# FINAL Initial Study/Mitigated Negative Declaration

Bowerman Power Renewable Natural Gas Plant Project

October 2025

Figure 3.2-1A **KOP 3: Portola Overlook Trail**

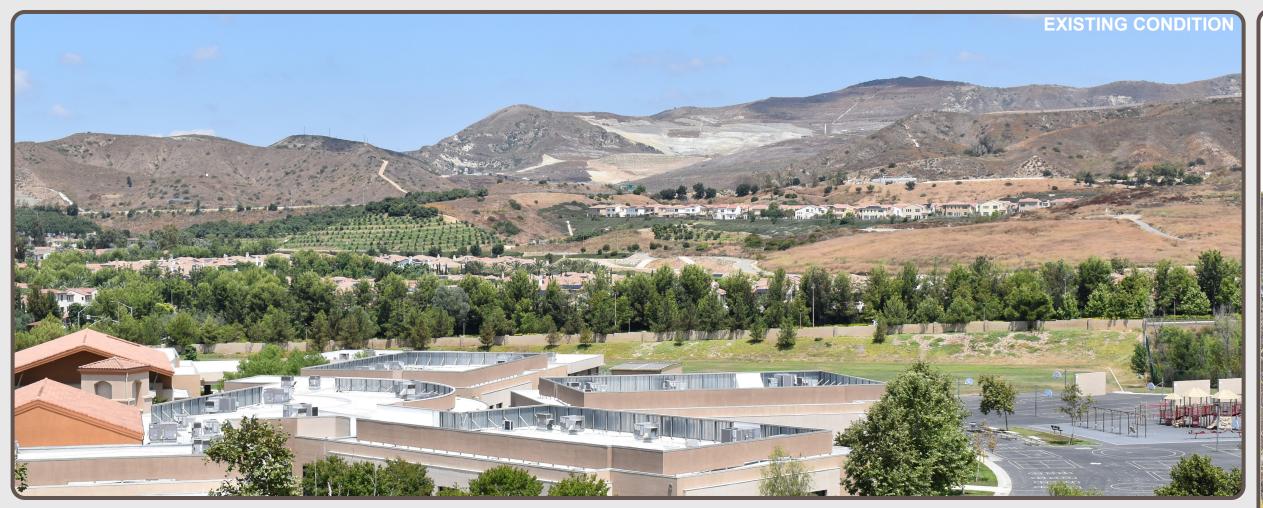
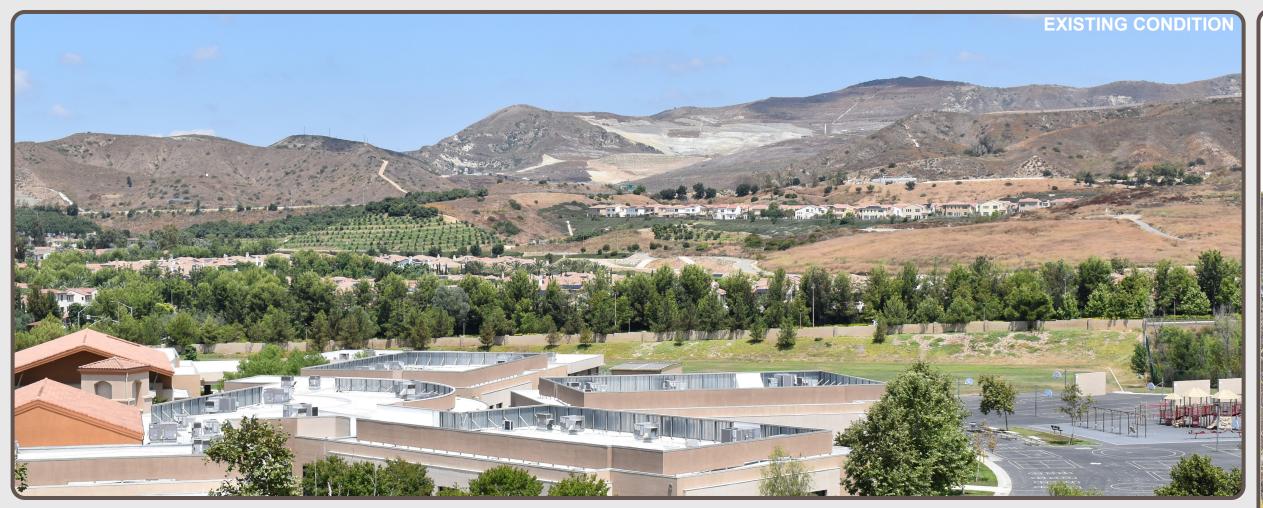
Aesthetics. Landscaping should be installed to screen the facility from the nearest residential neighborhoods within City limits - key observation points (KOP) 3 and 4. While the IS/MND states the facility would be barely visible, the photo simulations clearly show it is visible from those observation points.

As discussed in Section 3.4.1 of the Original Draft IS/MND, while the Project RNG Plant infrastructure would potentially be visible from KOPs 3 and 4, it would be barely visible and would not attract the attention of the casual viewer. The "casual observer" is considered an observer who is not actively looking or searching for the Project RNG Plant, but who is engaged in activities at locations with potential views of the Project RNG Plant. Original Draft IS/MND Figures 3.4-4 and 3.4-5 provided simulated views of the Project from KOPs 3 and 4, respectively. As the Project is difficult to see from these views, indicator arrows were added to facilitate locating the Project. However, indicator arrows can also exaggerate how easy it is to see a feature. For a more realistic visual experience, these figures have been updated. As shown in Final IS/MND Figures 3.2-1A and 3.2-2A, the Project is very difficult to locate. Even highlighted, as shown in Final IS/MND Figures 3.2-1B and 3.2-2B, the Project is barely noticeable. This clarification is added to the Final IS/MND, see Section 4.

Therefore, the Project RNG Plant, while having potentially visible features, would not attract the attention of the casual viewer, and impacts would be less than significant. As impacts are less than

significant, mitigation is not required. In addition, landscaping would not be feasible. In response to OCFA direction, the Project has been designed to comply with OCFA's Fuel Modification and Maintenance Program. Vegetation management has proven to be a major factor in protecting buildings from wildfires. In adherence to the Fuel Modification and Maintenance Program, the RNG Plant site will be located on an area that will be devoid of vegetation or other fuel sources. An additional 0.8 acre will be cleared of vegetation; see the area shown in red and yellow on Figure 2-11 of the Final IS/MND. Another 0.05 acre will be cleared of vegetation and trenched for installation of a fire suppression water line. Post-construction, the areas shown in red, blue, and yellow on Figure 2-11 will be revegetated with low fuel vegetation approved by OCFA and OCWR.
